Attachment 1 - PLN17/0959- 1E Marine Parade- Subject Site

1E Marine Parade, Abbotsford

Urban Design Memo

To:	Patrick Sutton	Date:	20/03/2018
Company:	City of Yarra	From:	Hansen Urban Design
RE:	1E Marine Parade, Abbotsford

Diagram demonstrating the proposed massing strategy (line of sight opposite side of road)

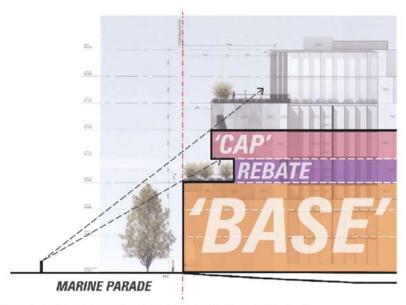
The proposed massing strategy should adopt a 3 storey 'base' with upper level forms comprising a rebated 4^{th} storey and 5^{th} storey 'cap', motivated by the following urban design response:

- Minimise the visual impact of upper level forms when viewed from north of Marine Parade:
- Minimise potential visual bulk impact of upper level forms by adopting three dimensional articulation;
- Consideration for 'lightweight' material treatment to distinguish the 'base' and 'cap';
 and
- Adopt a rebated level to add visual depth and provide a shadow line to further distinguish the 'cap'.

Please refer to diagram overleaf.
